**From:** Karen Beare <zbkarli@me.com>  
**Sent:** 01 February 2016 08:31  
**To:** Thuaire, Charles  
**Cc:** Anthony Beare; Mary-Jane O'Neill; Bob Warnock; Michael Hammerson; Tye Blackshaw; Mary Cane; Jane Shallice; Elspeth Clements; Marc Hutchinson; Lynda Cook; Harley Atkinson; Susan Rose; Dr Colin Cooper; Georgia Abrams; Richard Stokes; Derrick Dale QC; Berry, Sian (Councillor); Gimson, Sally (Councillor); Lewis, Oliver (Councillor)  
**Subject:** Water house - build plot ratio

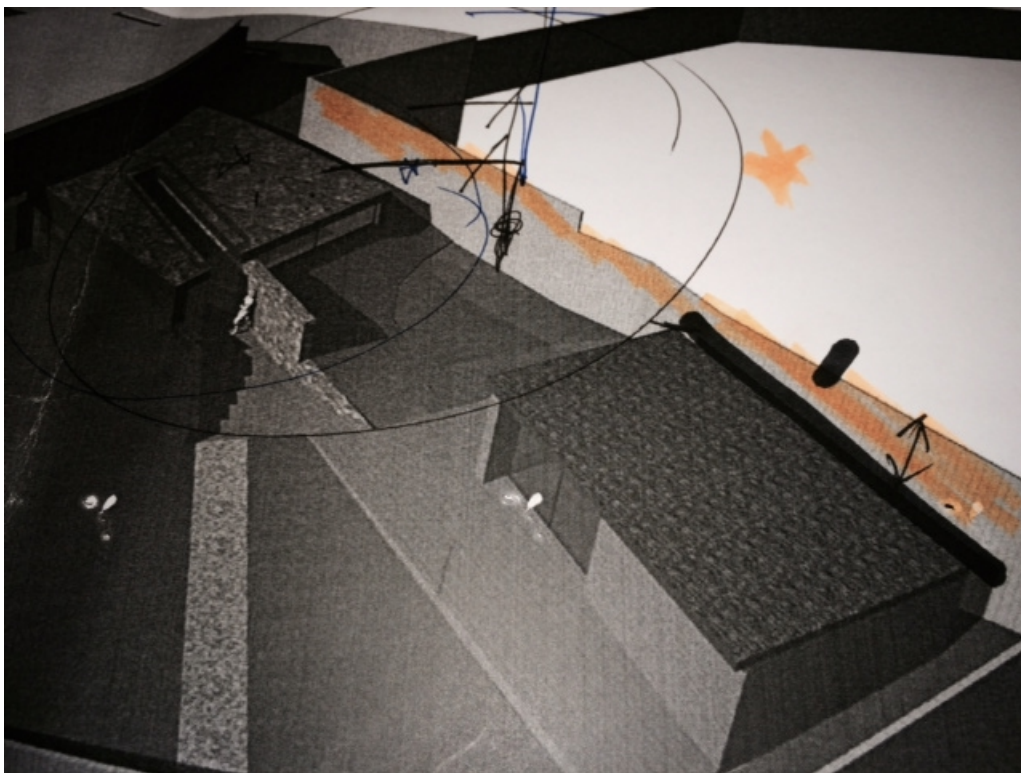
In the FOI emails you specifically flag the boundary fence which is shown being almost as high as the first floor roof. Of course it is nothing like this in real life so this is yet another transparent attempt to mislead the process.

My orange annotation below shows that the fence is shown almost twice as high as it should be. One marker is the studio roof height. The top of the fence should be a tad lower than the studio roof. The result of a very high fence is that the gym bund profile looks considerably lower than it will be in reality.

The other point relates to my beech tree where there is a black line and circle on the annotation. In the tree report Landmark confirm they will need to remove lateral branches at low level to facility the gym development.

The maths is compelling. The lowest lateral branch is about 2.5 above our ground level (I can easily walk under it) and our ground level is 1.5m higher than their current back garden. So our lateral branch is a minimum of 4m above their ground level. So why do they need to remove the branches to my tree if the gym is only a cut and fill basement showing little change to the topography?

Of course, if the fence was shown at the correct height, with our lateral branch just projecting over it, the 'real' raised topography of the basement gym would be obvious. I also note that no-where do you ask for the final level dims, as compared to existing topographical survey. This would of course provide the true increase in height of the gym bund and of the proposed total footprint.
